Title: Advisory Committee on Reactor Safeguards  
ESBWR Subcommittee: OPEN SESSION

Date: Wednesday, June 17, 2009

MEETING OF THE SUBCOMMITTEE ON THE ESBWR DCD

(CONTAINMENT ISSUES)

Figure 1. MSLB, 1 DPV failure (bounding case) – containment pressure (30 days) (RAI Figure 6.2-140 S04-C1)

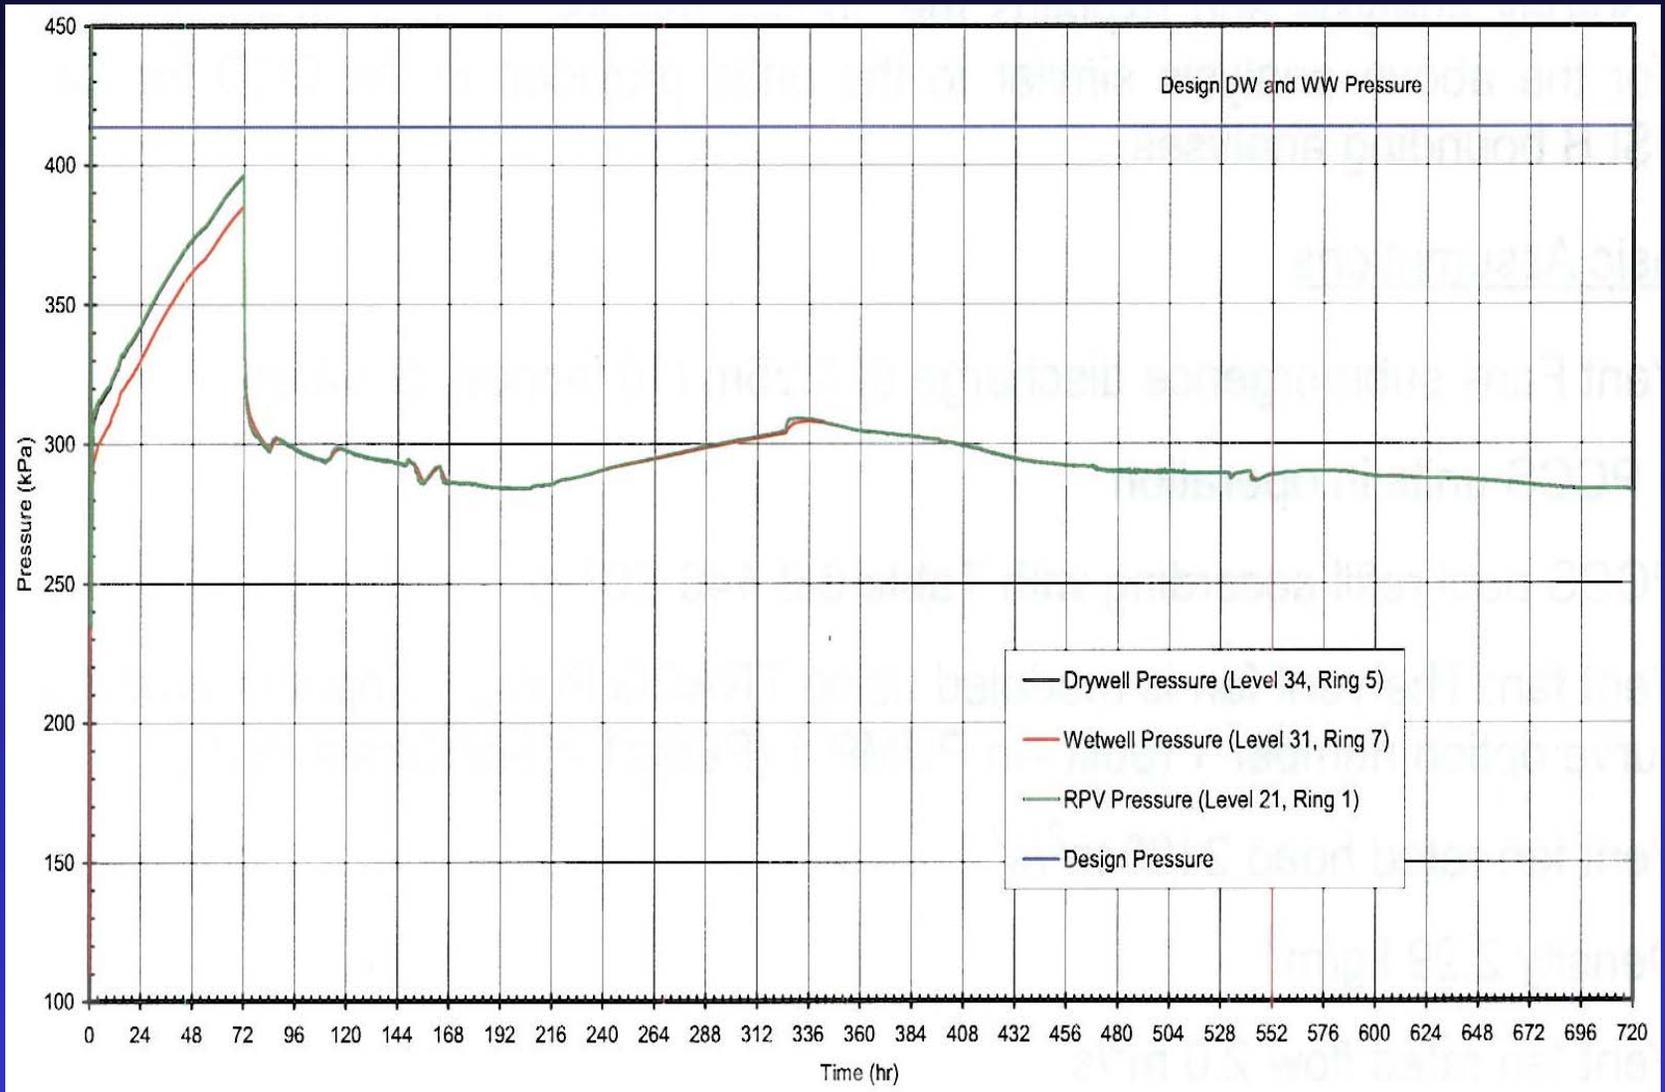
20 DR. WAGAGE: That's right. I am going to  
21 come to that. Because, as I said, the last point, the  
22 pressure is increasing; that is your concern. We have  
23 a concern that we have to resolve the differences, but  
24 we have found that the GE analysis done with TRACG  
25 does not show that pressure increasing. The pressure

11 These calculations, which are TRACG for  
12 the six-fans case, show that containment pressure  
13 stays below the design value for all 30 days. The  
14 design value is shown on the top horizontal line, 411  
15 kilopascals containment pressure driving and make the  
16 water stay below the design value.

Figure 3. Wetwell-to-drywell vacuum breaker (DCD Figure 6.2-28)

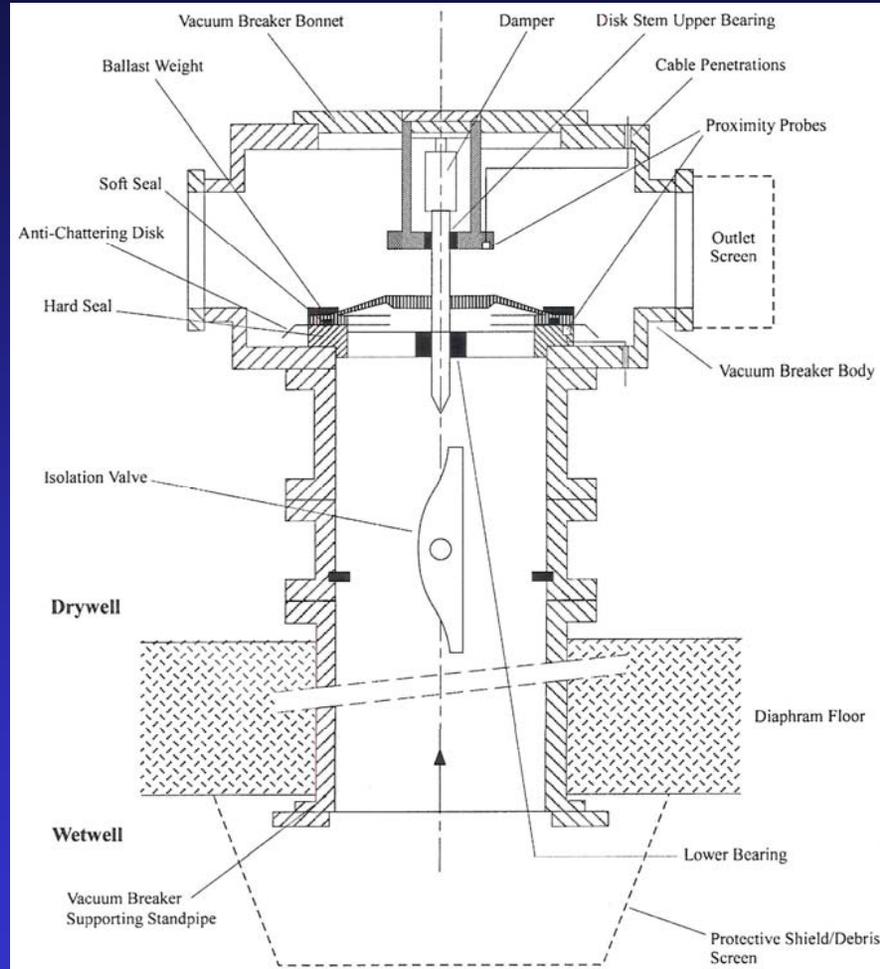
19 CONSULTANT WALLIS: Well, the one that is  
20 in the pipe, it is really pretty indistinct because  
21 you don't show how long the pipe is and where it is in  
22 the pipe. How long is that pipe?

22 CONSULTANT WALLIS: This is going to be a  
23 long way away because in the figure it is just at the  
24 mouth of the pipe, which makes no sense at all.

2 CONSULTANT WALLIS: Yes, but, see, when  
3 you show a figure like this, somebody might install it  
4 there.

8 MR. DIAZ-QUIROZ: Yes, it is shown there.  
9 Why it is shown there, it is to show that it is  
10 local; it is not like the other drywell temperature,  
11 where it is away, where you could be too far away from  
12 that entrance.

Figure 3 – VB Isolation Valve – Offset Details

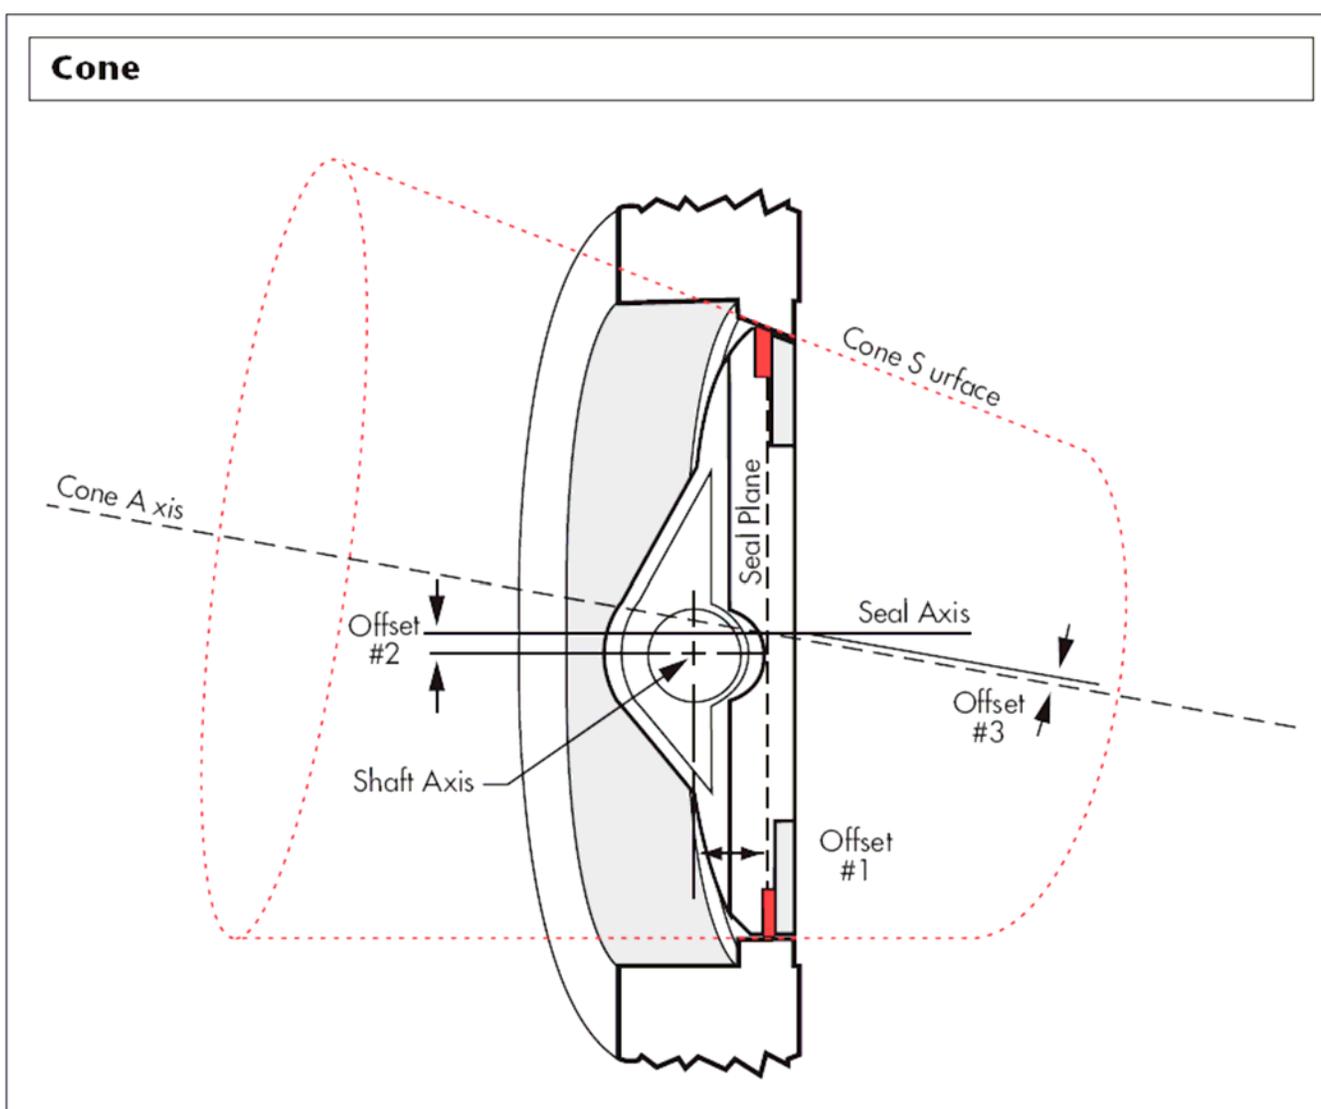
4 CONSULTANT WALLIS: If you look at the  
5 next figure, I don't understand how you could ever  
6 rotate it because it is held on both sides. How can  
7 you rotate that thing? It has to sort of pick up one  
8 side at a time and then --

10 CHAIRMAN CORRADINI: So may I ask a  
11 question? Since you talked about the seat rubbing, if  
12 you look at your figure and you turn it so that you  
13 are looking from right, is at the bottom of the page,  
14 and up is at the top -- or I'm sorry. Left is at the  
15 top.

16 So on the one seal plane which is angular,  
17 versus the seal plane which is at right angles, is  
18 there any torque or stress put on the seat, on the  
19 seal point itself? Because it seems, the way you  
20 described it, since it doesn't move on the axis, it  
21 just turns, you put some stress as it is opening up or  
22 as it is closing down, but it's not putting any stress  
23 on the seal?

16           It isn't something that is easy to  
17 visualize, especially in three dimensions when you're  
18 looking at a two-dimensional figure. But it is  
19 because of that geometry and the pivot point of the  
20 disc that you don't get any rubbing between the disc  
21 and the seat.

21                  MR. WALKER: I'm sure this is just a  
22 cartoon. It looks more representative of the angle  
23 that you would see at the top of the figure on page 9.  
24 I think it's closer to -- you know, it is a much  
25 shallower angle at the bottom of the disc, of the
